SEQUOYAH NUCLEAR PLANT (SQN) - UNITS 1 AND 2 - TECHNICAL SPECIFICATION (TS) CHANGE NO. 00-06, REVISED RESPONSE TO REQUEST FOR ADDITIONAL INFORMATION (RAI) (TAC NOS. MB2972 AND MB2973)

TENNESSEE VALLEY AUTHORITY
SEQUOYAH NUCLEAR PLANT (SQN)
UNITS 1 AND 2
DOCKET NOS. 327 AND 328

RESPONSE TO REQUEST FOR ADDITIONAL INFORMATION (RAI)
TECHNICAL SPECIFICATION (TS) CHANGE 00-06

Figure 20-1
Axial Power Shape for Guide Tube Boiling

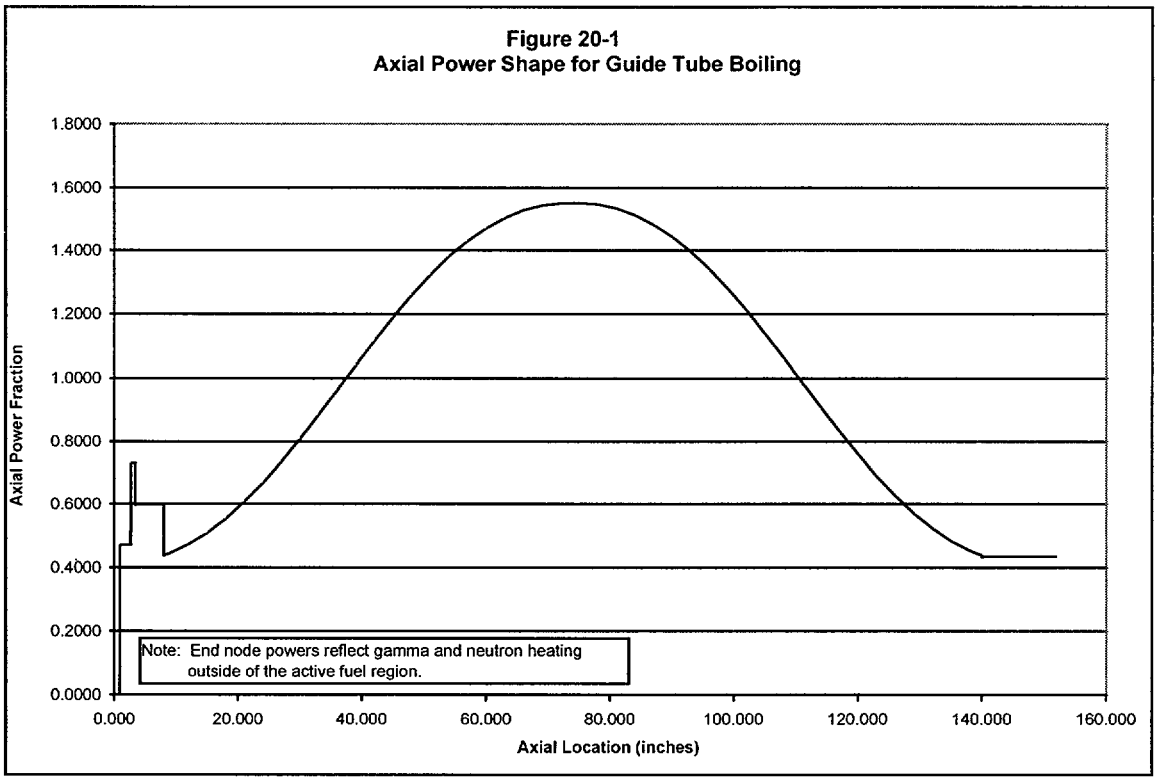
d. Please provide a profile for the bounding axial power shape that was used for these analyses and discuss how it was conservatively selected.

containing the TPBAR and the surrounding channels. The axial power shape used in the analysis of record was a symmetric axial shape with a 1.55 axial peak (see Figure 20-1). A scoping study was performed to evaluate inlet, outlet, and symmetric axial shapes of different magnitudes. From that study it was determined that, since guide tube boiling is a long-term phenomenon, a symmetric axial shape with a 1.55 magnitude peak conservatively represents long-term, steady-state operation.

The maximum bulk coolant temperature in the guide thimble containing the TPBAR was shown to be 651.4°F, which indicates >1°F margin to the saturation temperature at 2250 psia, with a 0.8% margin in local quality. The maximum cladding surface temperature was shown to be 654.4°F, against a design value of 662.4°F, while the clad surface temperatures within the dashpot region were less than 600°F, well below the temperature range where surface boiling would occur.
